DESCRIPTION Expansion Dam Detail
PROJECT Sandy River Bridge Proj. No. BH-025-2(46)
LOCATION New Sharon, Me.
DESIGNER Me. D.O.T.
CUSTOMER Callahan Bros., Inc.
JOB NO. 89-670-4
DWG. NO. 22
REV. ②

STATE OF MAINE
DEPARTMENT OF TRANSPORTATION
☒ Approved ☐ Returned for Corrections
AUG 16 1989
☐ Approved as noted ☐ Rejected
K. Jacobs
WELDING ENGR.

DESCRIPTION SPLICE PLTS FOR LINK RETROFIT
PROJECT SANDY RIVER BRIDGE PROJ. No. BH-025-4(26)
LOCATION NEW SHARON, ME
DESIGNER ME DOT
CUSTOMER CALLAHAN BROS.
JOB NO. 89-670-2   DWG. NO. 1   REV. (A)

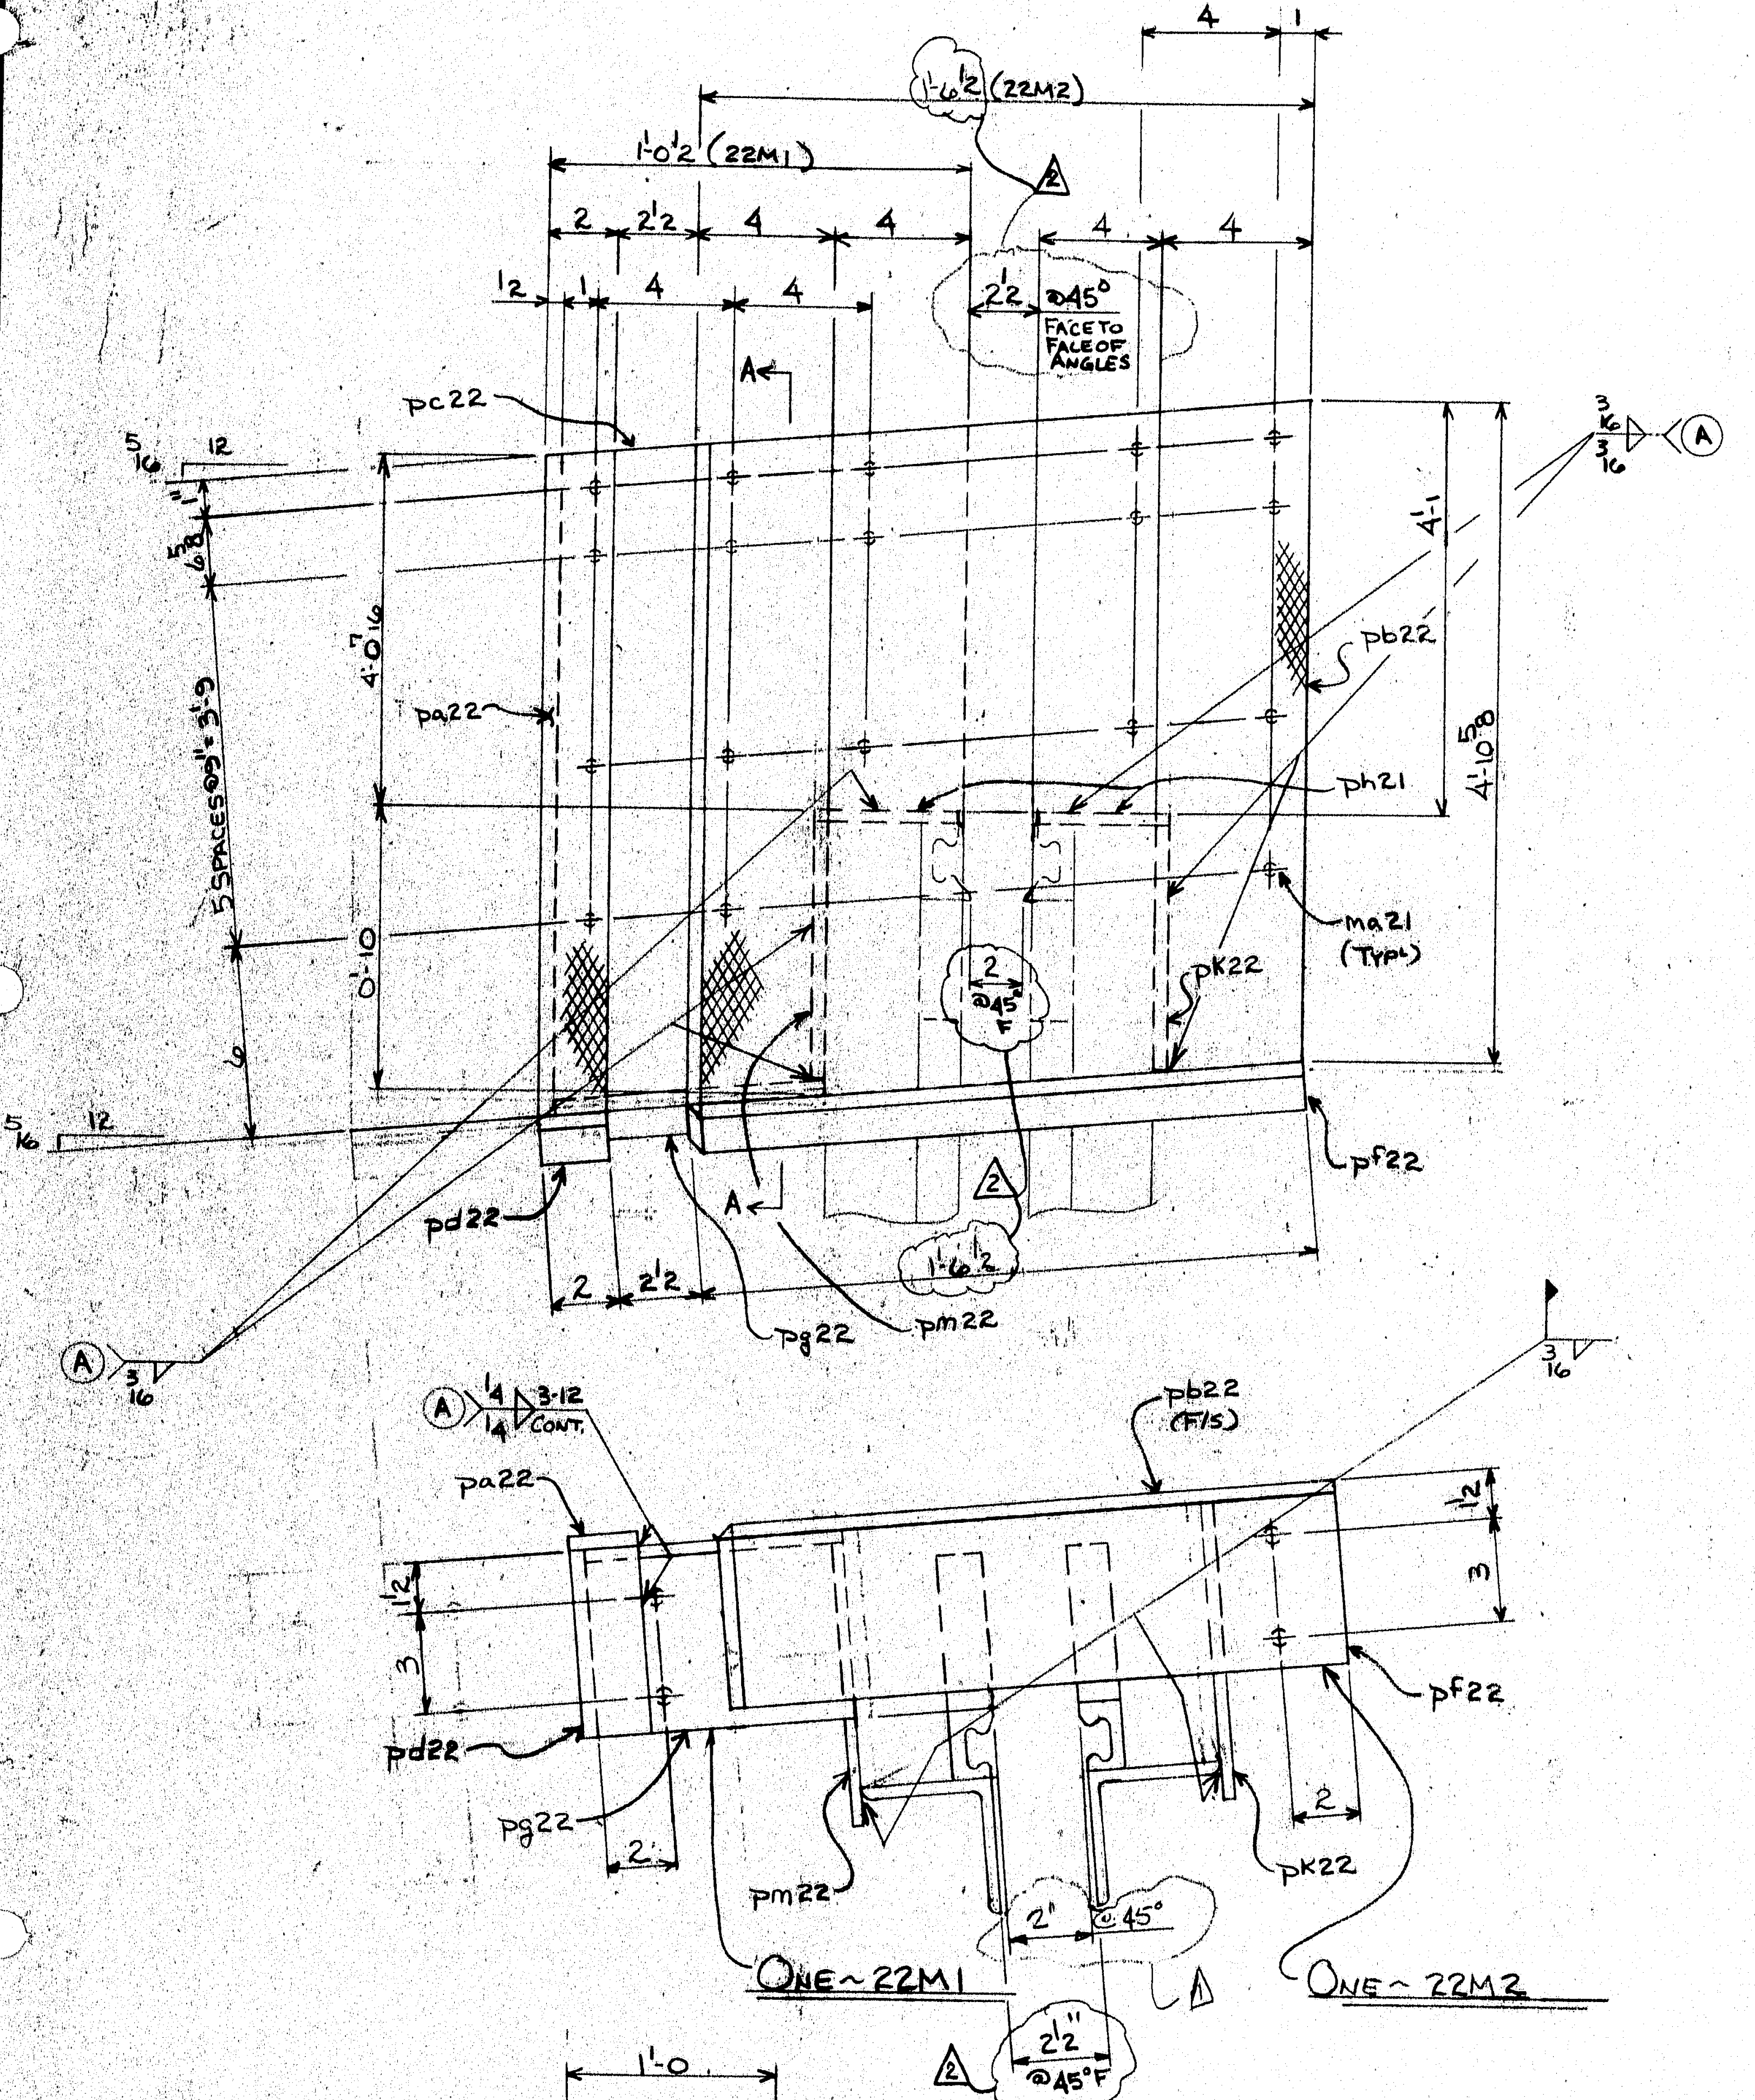
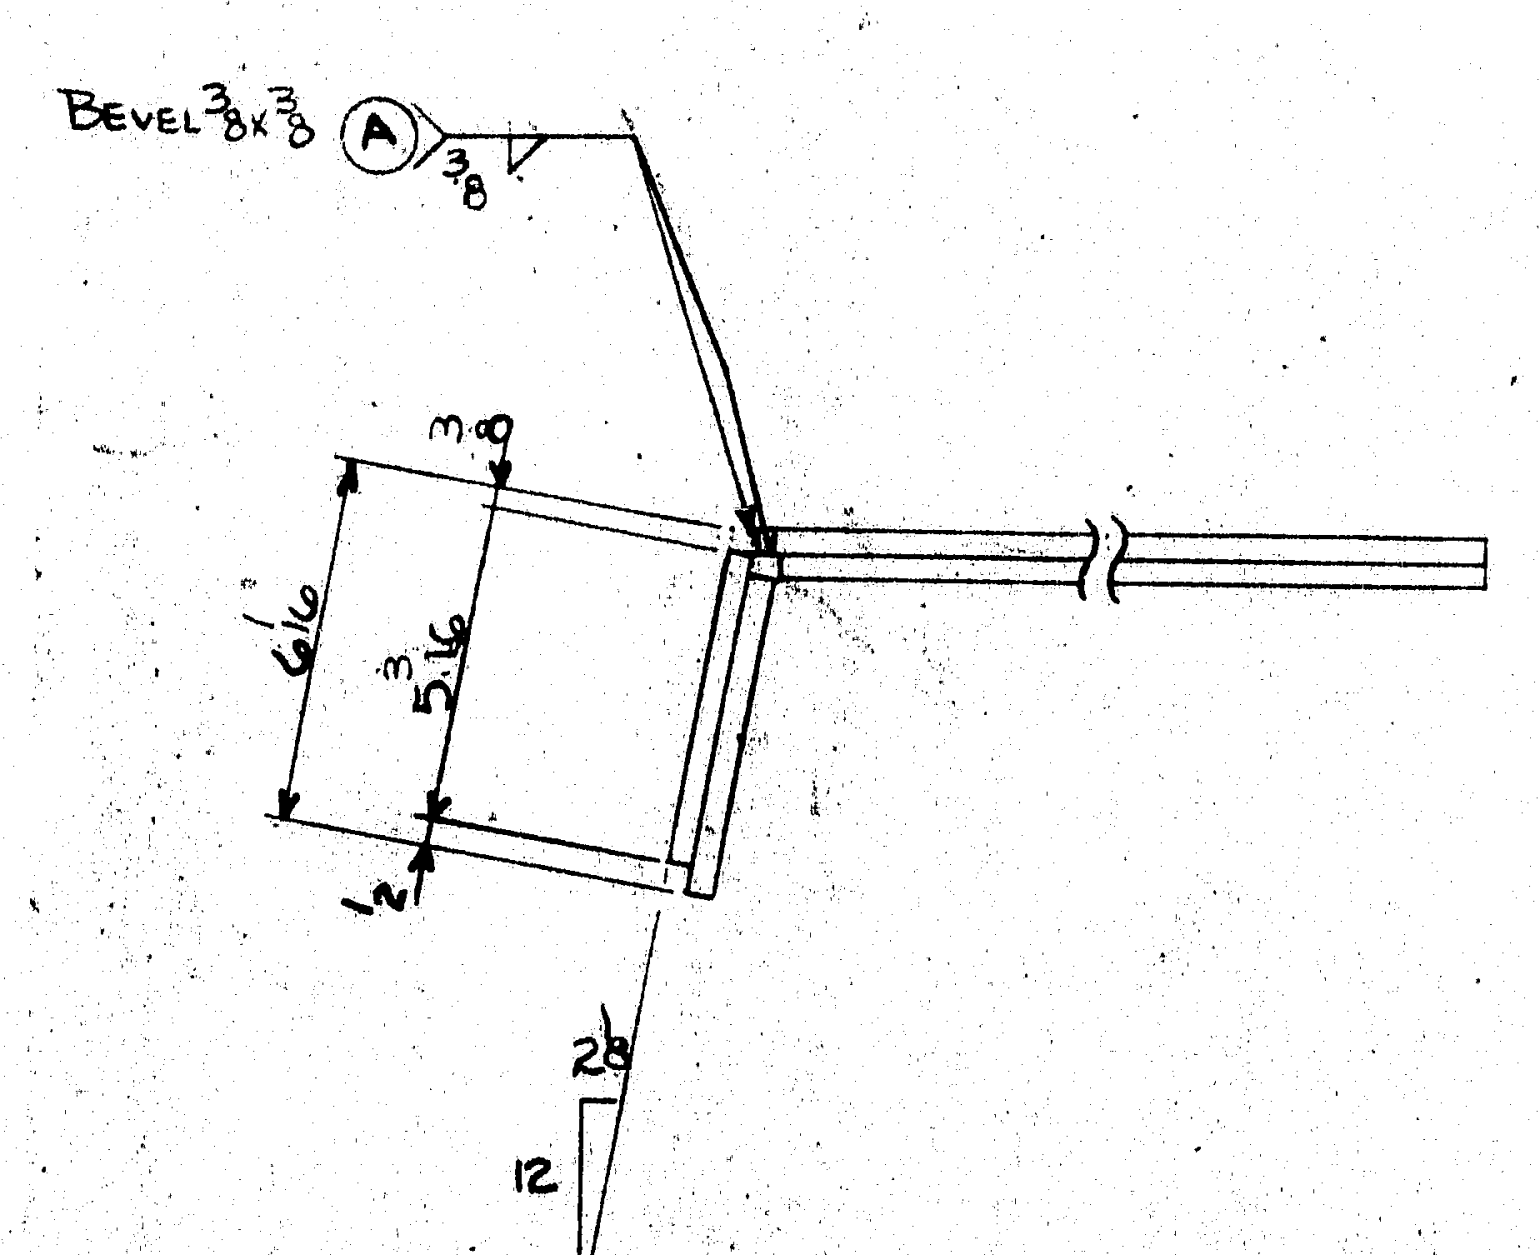
Added Dimensions Pay Item # 520.21
② Changed 1'-6 to 1'-6½
① Revised Dim. on pb22
Ⓐ Revised Per Approval
